WORK ORDER NON-CONFORMANCE / UPDATE

DESIGN <i>CP</i>	DRAWN BY <i>CP</i>	DART AEROSPACE LTD HAWKESBURY, ONTARIO, CANADA	
CHECKED <i>#</i>	APPROVED <i>#</i>	DRAWING NO. D3016	REV. A SHEET 1 OF 3
DATE 01.05.18		TITLE SEAT FRAME ASSEMBLY	SCALE NTS
A	01.05.18	NEW ISSUE

DRAWING NO. D3016	TITLE SEAT FRAME ASSEMBLY	REV. A	DART AEROSPACE LTD ENGINEERING ORDER	D.E.O. NO. D3016-A-1	SHEET NO. SHEET 1 OF 1	SCALE NTS
DRAWN <i>1</i>	CHECKED <i>UP</i>	MFG. APPR. <i>RE</i>	APPROVED <i>MAP</i>	DE APPR. <i>TH</i>		
DATE 10.01.29	DATE 10.01.29	DATE 10.01.29	DATE 10.01.29	DATE 10.01.29	DATE 10.01.29

TO REVISE D3016-11 SADDLE'S HOLE SIZES

D3016-11 SADDLE

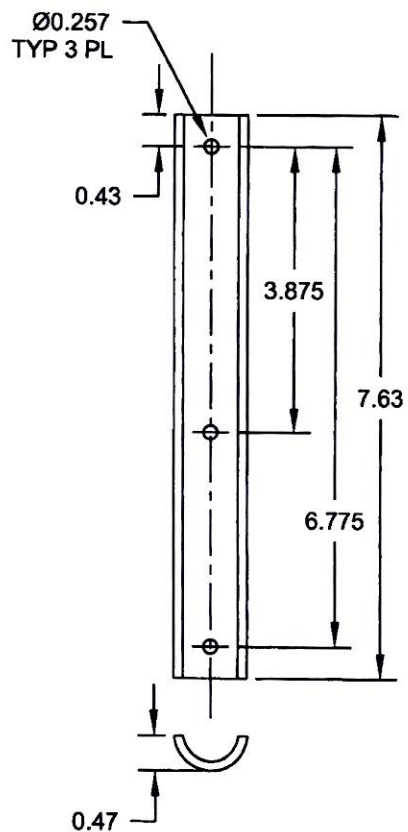
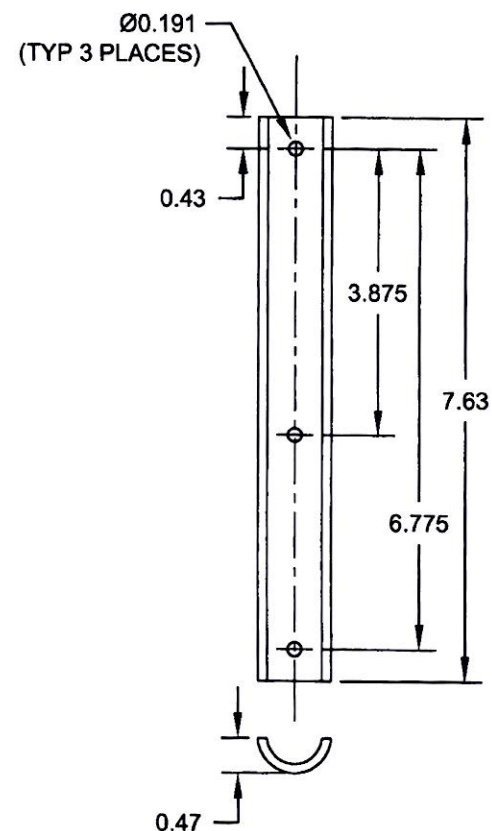
DETAIL D3016-11 SADDLE (SHEET 3): Ø0.257 TYP 3 PL WAS Ø0.191 (TYP 3 PLACES) AS SHOWN:
